A10.0 - SPURIOUS EMISSIONS TEST

Beacon Unit : 2/2
 Name : JOTRON
 Type : TRON 40GPS
 Number : 7001

Change of rise/fall time of the 406 MHz modulation

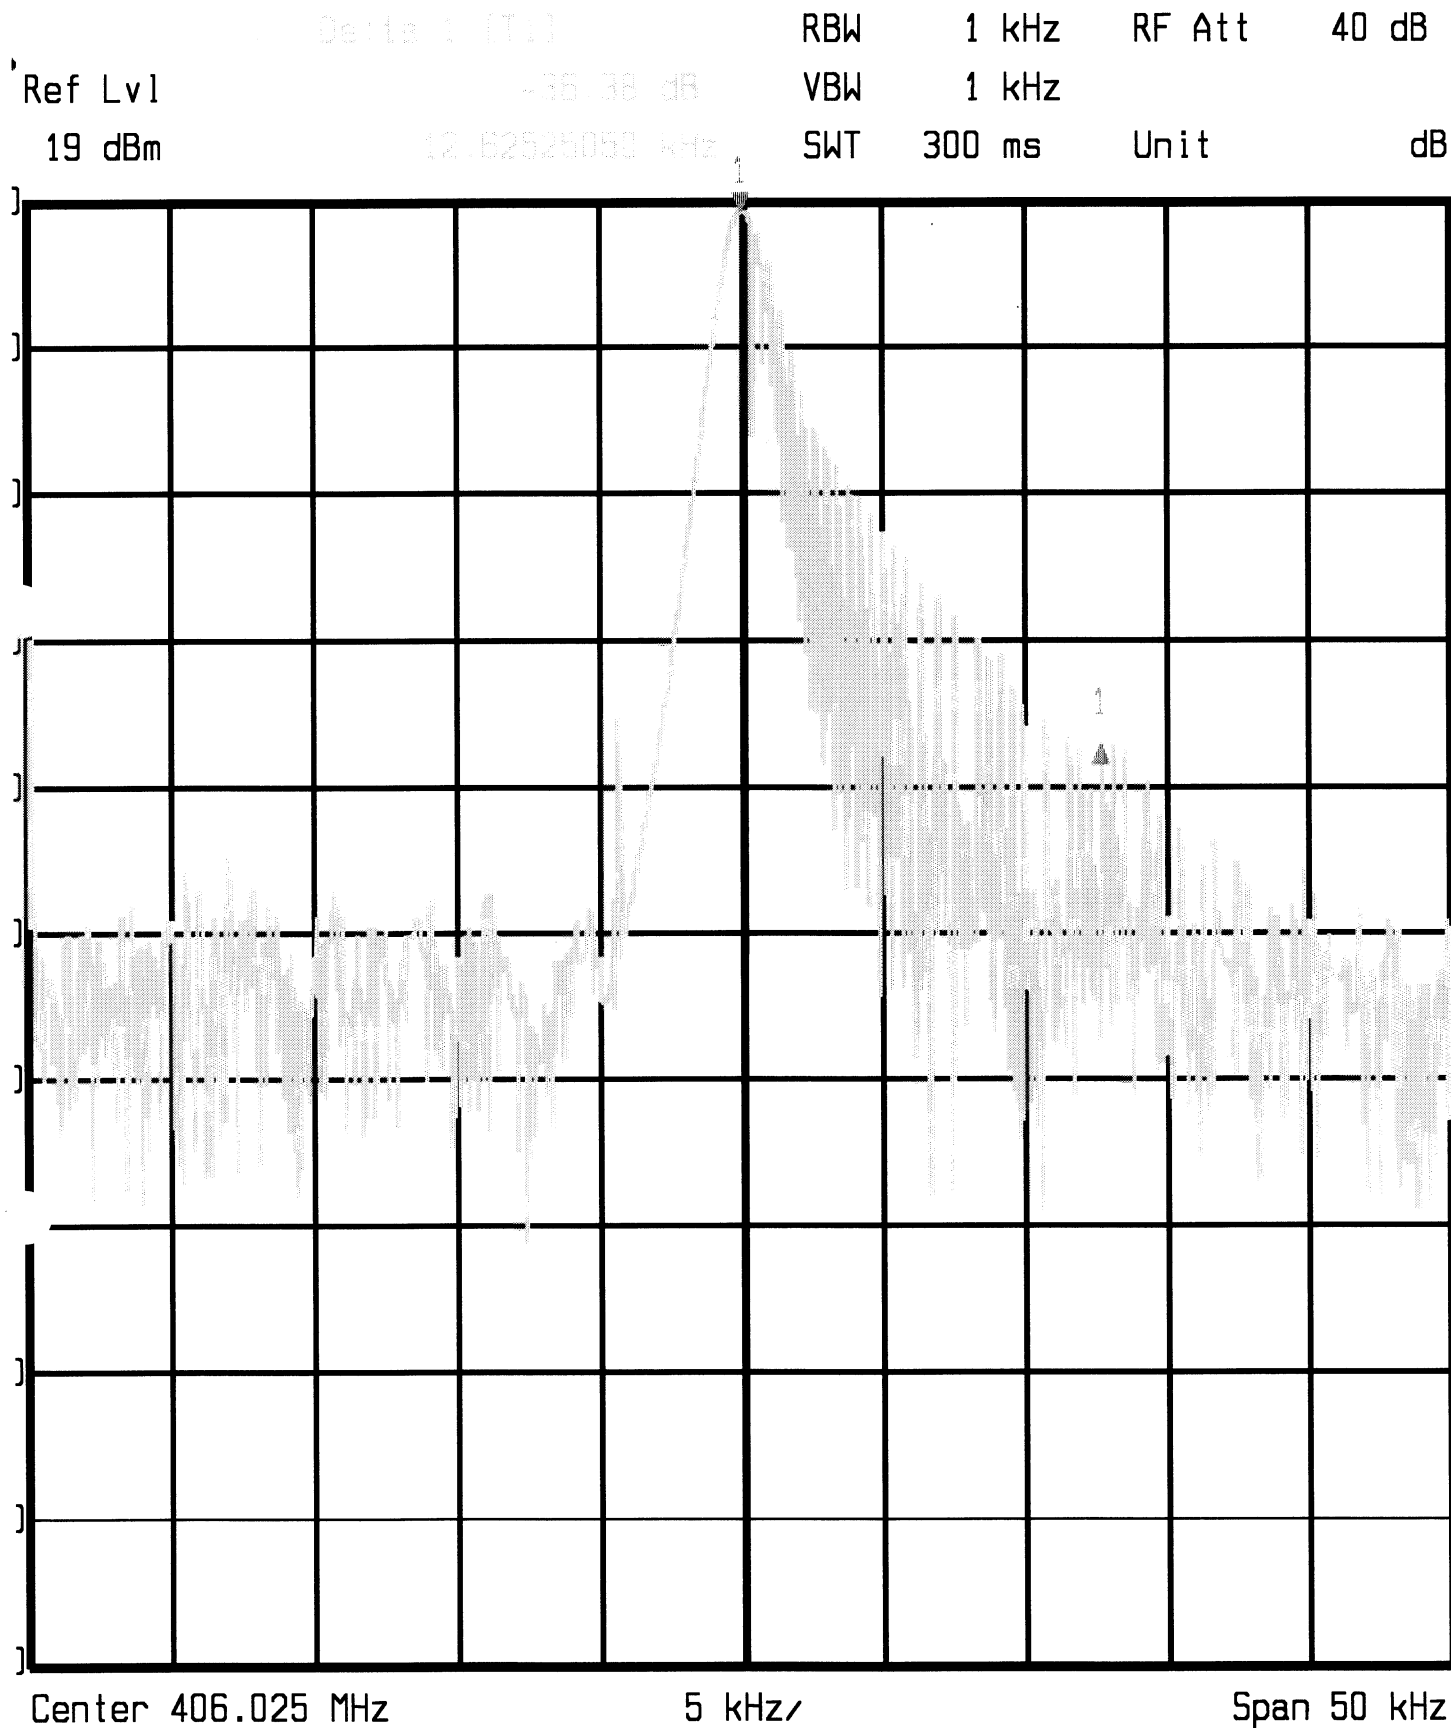
We have done a modification that we will introduce on all new beacon of type Tron40GPS regarding the rise/fall time of the modulation to suppress spurious effects. This is done by changing the capacitor C209 from 15nF to 47nF. This will be a stronger low pass filter consisting of R212 (10 k) and C209 (47 nF). Below is a printout from our oscilloscope of type TDS210 (registration number: JOT259, calibrated:16.8.2000). REFA is with 15nF capacitor, REFB is with 47 nF:

As seen on the curves, the rise time is increased from approx. 50 to 150 uS.
JOTRON, Tjodalyng 20.10.2000
